U.S. Department of the Interior	
BUREAU OF LAND MANAGEMENT

Notice of Intent

Type of Action: APD Change

Procedure Description: XTO Permian Operating, LLC. respectfully requests approval to make the below listed changes to the approved APDs. 1. Casing design to be changed from the "4-String Design – Engineered Weak Point" (FIGURE F) to the "4- String Design – Open 1st INT x 2nd INT Annulus" (FIGURE D). An open annulus will be utilized and monitored during completions operations. Post completion, bradenhead squeeze will be performed to tie back the 1st intermediate x 2nd intermediate annulus. TOC will be placed into the 1st intermediate shoe but still below the base of Potash interval. 2. No changes to the cementing, casing or mud circulating system designs will be required for the requested change. 3. There will be no new surface disturbance. Please refer to the R-111-Q well bore diagrams in the attachment reflecting the changes requested.

[Figure F] 4 String - 2nd Intermediate casing engineered weak point

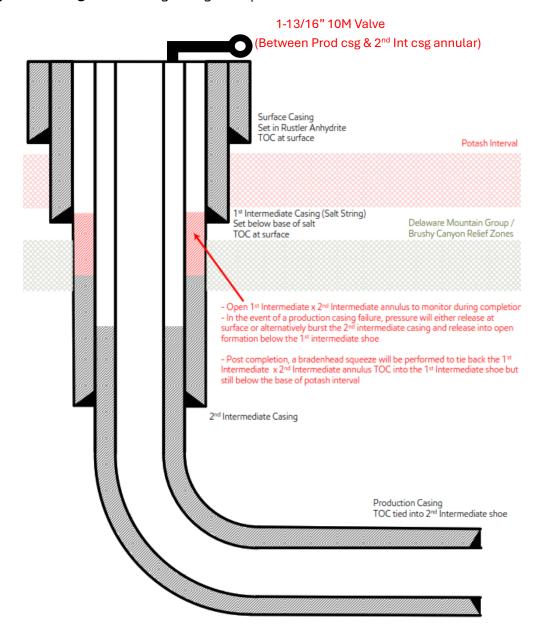
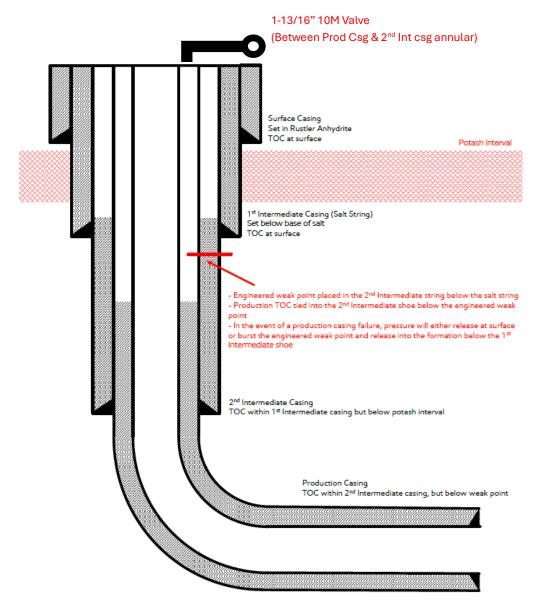
1. Casing design to be changed from the "4-String Design – Engineered Weak Point" (FIGURE F) to the "4-String Design – Open 1st INT x 2nd INT Annulus" (FIGURE D). An open annulus will be utilized and monitored during completions operations.

Post completion, bradenhead squeeze will be performed to tie back the 1st intermediate x 2nd intermediate annulus. TOC will be placed into the 1st intermediate shoe but still below the base of Potash interval.

- 2. No changes to the cementing, casing or mud circulating system designs will be required for the requested change.
- 3. There is no new surface disturbance.

- 1) Alignment with KPLA requirements per schematic per schematic below, with engineering weak point casing design and utilizing new casing that meets API standards.
- 2) Contingency plans in place to divert fluids away from salt interval in event of production casing failure.
- 3) Intermediate 2 casing will consist of a primary cement job with TOC at the top of the Brushy Canyon formation within the Delaware Mountain Group.
 - a. Bradenhead squeeze to be completed after primary cement job to tie back TOC to intermediate 1 "Salt string" & below Marker Bed 126 "Potash Interval".
- 4) Production cement to be tied back no less than 500' inside previous casing shoe (intermediate 2 casing) and below the engineered weak point.

- 1) Alignment with KPLA requirements per schematic above, leaving open annulus open for pressure monitoring during frac and utilizing new casing that meets API standards.
- 2) Contingency plans in place to divert fluids away from salt interval in event of production casing failure.
- 3) **Intermediate 2 primary cement** job with TOC within Delaware Mountain Group with 0% excess & below the minimum 500' from intermediate 1 casing shoe
 - o **Intermediate 2 bradenhead squeeze** to be completed within 180 days after completions to tieback TOC to salt string at least 500ft but with top below Marker Bed 126.
- 4) Production cement to be tied back no less than 500ft inside previous casing shoe.
